# Access Compliance Report

## Public Rights-of-Way

Intersection ID: 48166	Main Street: NORTHLAKE_MALL_DR	Cross Street: NORTHLAKE_CENTRE_PY	Location: SE
ADA ID: E7800904FEC9	Ramp Type: Perp	Initial Pass/Fail: Fail	Overall Compliance: No
Severity Score: 33.75			
Codes/Mitigation Info/Possible Solution		Field Measurements/Component Compliance

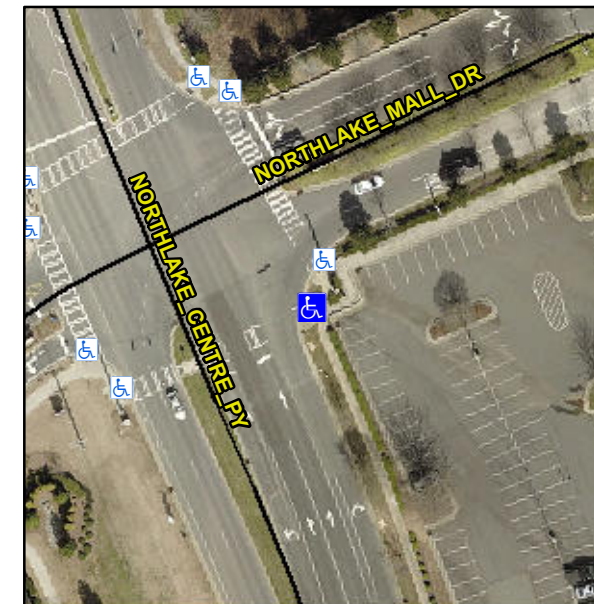
**Not Found, R304.5.1, R304.2.2, R304.5.3**

Compliance	Description	Data	Compliance	Description	Data
N/A	Ramp Length (in)	94.0	No	Ramp Slope (%)	9.5
No	Ramp Width (in)	45.5	No	Ramp XSlope (%)	5.1
N/A	Flare Type LT	N/A	N/A	Flare Type RT	N/A
N/A	Flare Slope LT (%)	N/A	N/A	Flare Slope RT (%)	N/A
N/A	Flare Traversable LT?	N/A	N/A	Flare Traversable RT?	N/A
N/A	Landing Length (in)	N/A	N/A	DWS Provided?	N/A
N/A	Landing Width (in)	N/A	N/A	DWS Contrast?	N/A
N/A	Landing Slope (%)	N/A	N/A	DWS Length (in)	N/A
N/A	Landing X Slope (%)	N/A	N/A	DWS Full Width?	N/A
N/A	Landing Curb? (Y/N)	N/A	N/A	DWS Offset (in)	N/A
N/A	Shared Landing?	N/A			
N/A	Gutter Ponding?	N/A	N/A	Gutter Slope (%)	N/A
N/A	Gutter Lip Ht (in)	N/A	N/A	Gutter X Slope (%)	N/A
N/A	Painted X Walk1?	Yes	N/A	Painted X Walk2?	N/A
	X Walk 1 Direction	To SW		X Walk 2 Direction	N/A
N/A	X Walk 1 Width (in)	110.0	N/A	X Walk 2 Width (in)	N/A
	X Walk 1 Slope (%)	2.5		X Walk 2 Slope (%)	N/A
	X Walk 1 X Slope (%)	5.8		X Walk 2 X Slope (%)	N/A

**Remove & Replace Entire Ramp.**
